ADDENDUM FIVE

Roof Replacement at
Lincoln Manor
10 Franklin Street, Lincoln, RI

Lincoln Housing Authority
10 Franklin Street
Lincoln, Rhode Island

March 13, 2019

1
GUTTER DETAIL
 SKA-01 3" = 1'-0" REF 1 AND 6/A3.00

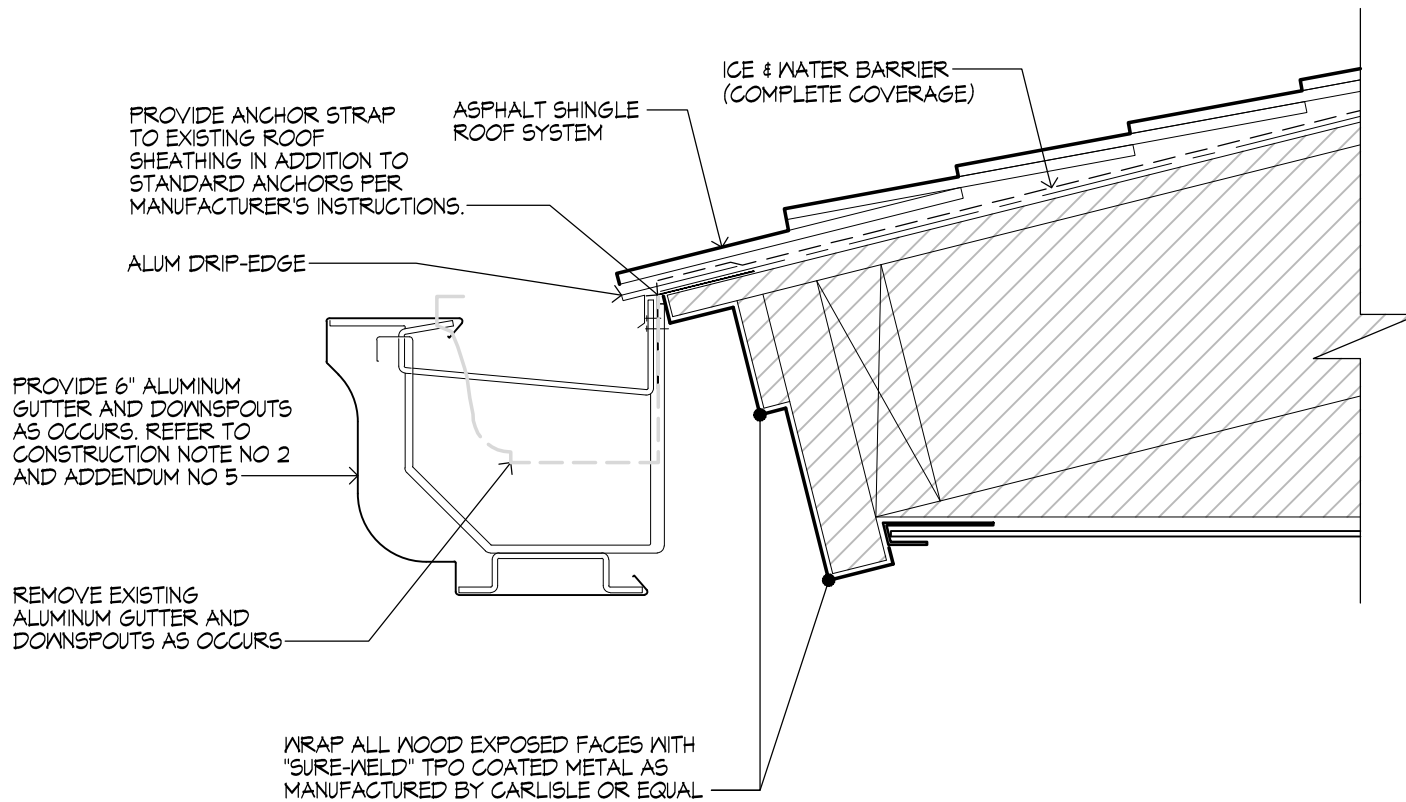
1. GUTTERS:
 - a. What profile have you selected?
Answer: SAF, Designer Series, Colonial Profile
 - b. What size gutter have you selected?
Answer: 6"
 - c. Can you provide a clearer detail as to how you want us to install it on the angled and stepped fascia securely and without the open backside of the SAF system being left exposed?

Answer: Provide roof deck fastening bracket supplied by manufacturer to secure the gutter to the existing roof sheathing. Provide in addition to, or in place of fascia fastening as required. See attached Sketch SKA-01 Gutter Detail for additional information.
